THE MILTON BICYCLE ADVISORY COMMITTEE
MILTON, MASSACHUSETTS

December 20, 2018

Per Ms. Tougias' request and in line with the town's Complete Streets Policy, the Bicycle Advisory Committee would like to share several suggestions for improvements to the Wolcott Woods / Carberry Estate development project.

Figure 1: Upgrade frontage path to a paved sidewalk, extend to the next driveway, and increase the width.

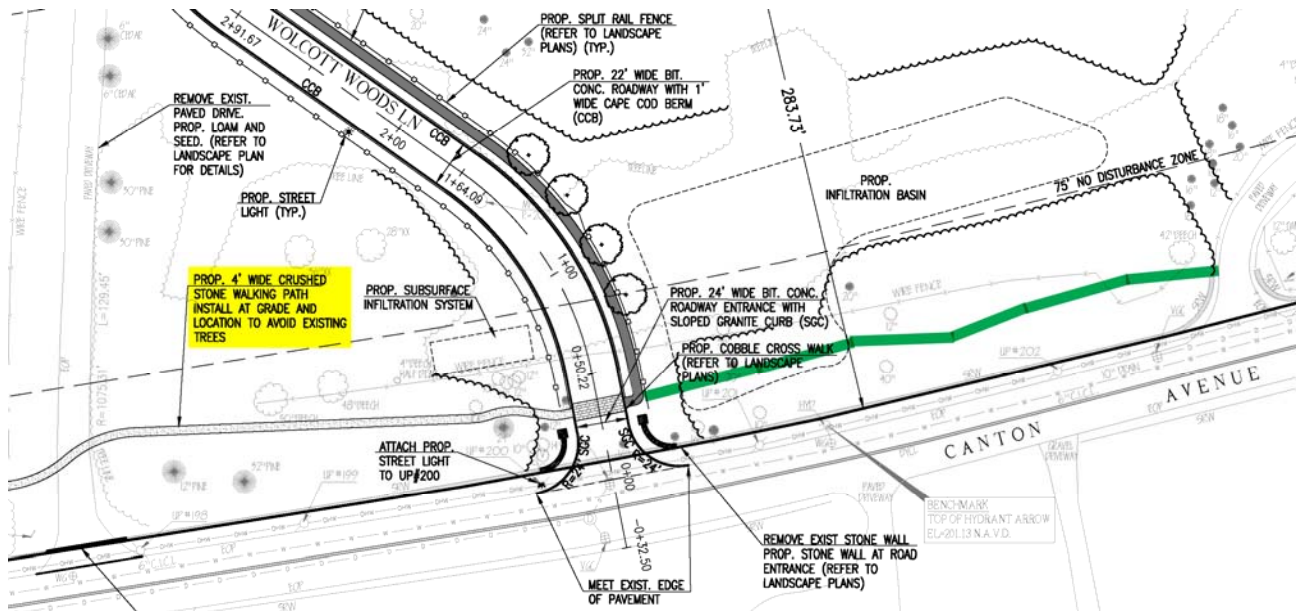
The developer has proposed to build a crushed stone walkway on the inside of the stone wall. The Committee commends the developer for including this design element. However, we recommend that the path be paved, it should be extended along the southern section of the frontage, and the width should be increased from 4.5 feet to at least five feet wide. For a comparable example, please see Codman Road in Lincoln. That paved walkway appears to be about eight feet wide.

Figure 2: Personal best bicyclist speeds northbound on Canton Avenue at Wolcott Woods site.

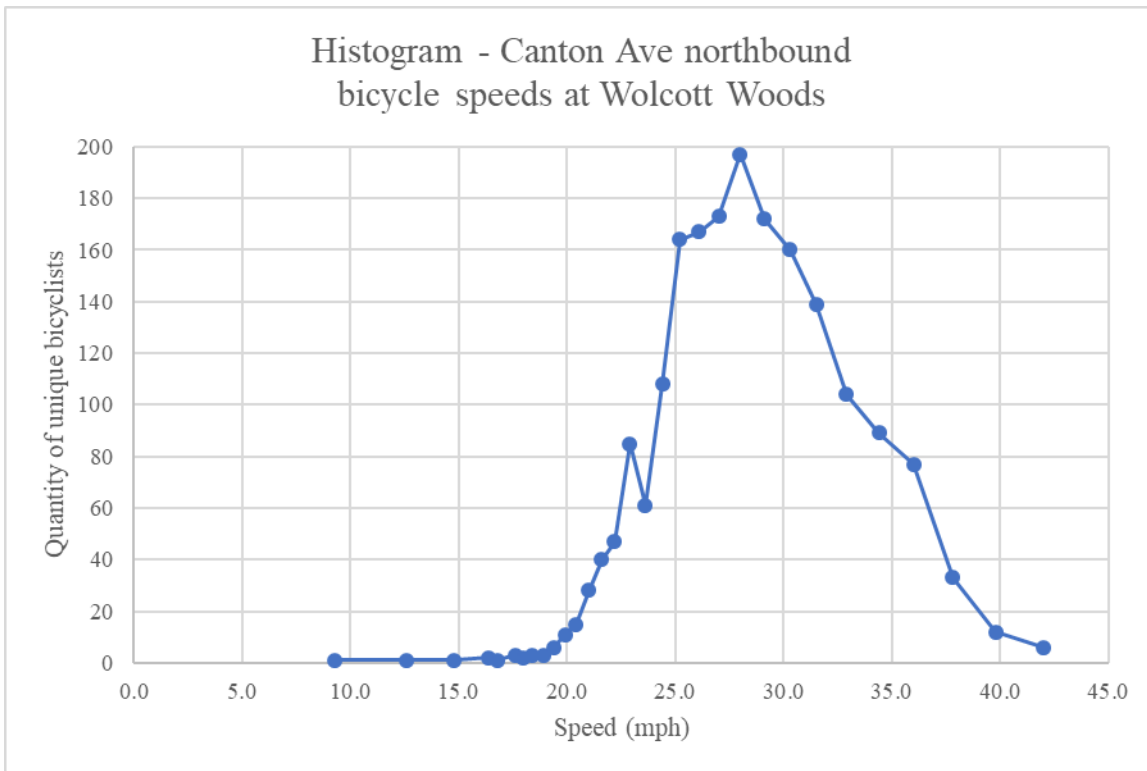
We have analyzed public bicycle GPS data from Strava and found that of 1,910 individual bicyclists, their peak speeds at this site range from 9.3 to 42.0 mph, with a median of 28.0. While the Strava leaderboard is biased higher than average speeds (because these are personal best speeds and the data set is based on enthusiasts who tend to use the service more than casual or commuter riders), it does represent actual bicyclist speeds on this downhill section of road.

For these reasons, we recommend that at the intersection where the private road enters Canton Avenue, the developer place a stop sign and a 'look for bicycles' sign.
